Sydney Heritage Fleet Maritime Facility – SLR Findings and Recommendations

This letter provides an initial report resulting from Evans & Peck's review and consideration of the flooding and climate change issues relating to the proposed Sydney Heritage Fleet (SHF) maritime facility at 3 Bank Street, Pyrmont. The proposal is being assessed by the Department of Planning and Infrastructure (DP&I) as a major project development application (MP11_0001).

Figure 1: Existing site of the proposed Parkland east of the proposed SHF maritime facility

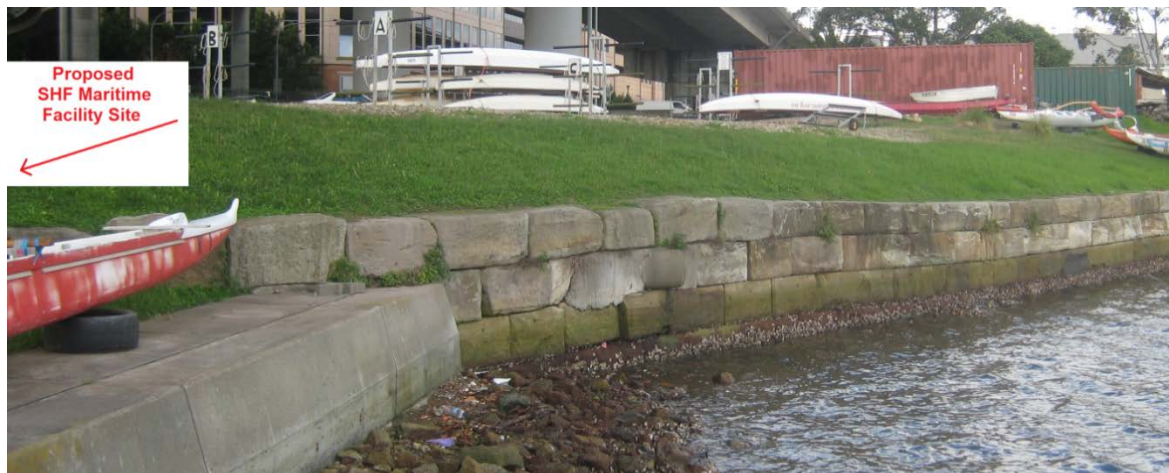
Should the Proponent choose to prevent inundation by utilising the seawall as a levee in the future, the Sea Level Rise report recommends the Proponent prepares '*monitoring and maintenance programs to reduce the risk of movement/erosion of the seawall*'. The seawall bounding the site is a relatively modern concrete structure (in contrast to the sandstone block structure to the east of the site on the right-hand side in Figure 1). Given the relatively modern construction of the concrete seawall (possibly in conjunction with the construction of the ANZAC Bridge pylon), Evans & Peck considers that any erosion of the concrete seawall from waves in Blackwattle Bay is unlikely to be a significant issue. Evans & Peck considers the comments from SLR to be more relevant to the sandstone block to the east of the site. However, Evans & Peck recommends that as part of the

- the structural integrity of the existing concrete seawall,
- the feasibility of raising the sea wall in the future,
- the vulnerability of the concrete seawall to erosion or undercutting, and
- the necessity for monitoring and maintenance programs as recommended in the Sea Level Rise report.
